KEMPS CREEK ESTATE – SSD-9522 MOD 3

Section 4.55 (1A) Modification

Prepared for
**FRASERS PROPERTY INDUSTRIAL & ALTIS
PROPERTY PARTNERS**
26 November 2021

Figure 27 Proposed Drainage System

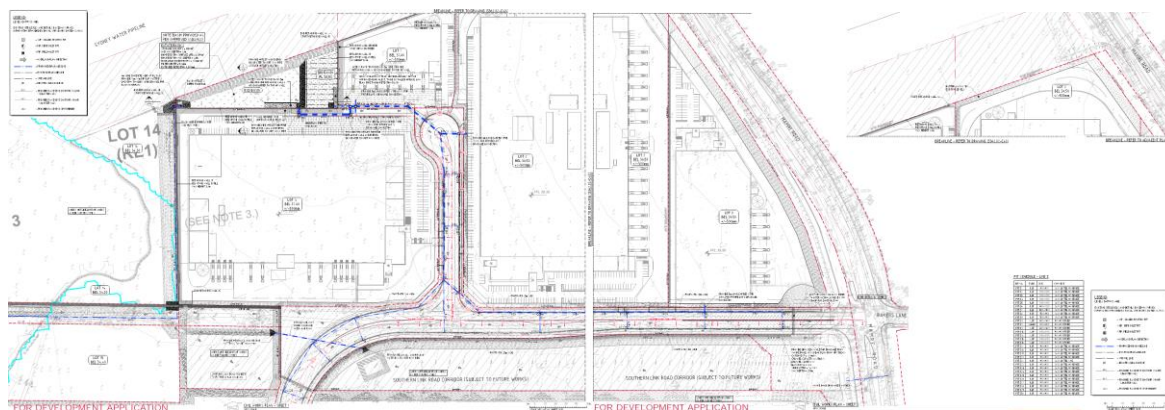
The modification seeks to adjust the stormwater drainage layout to remain consistent with the approved SSD and MOD1 while allowing for the revised lot configuration and new access road. The proposed adjustments to the drainage system are demonstrated in Figure 16 below.
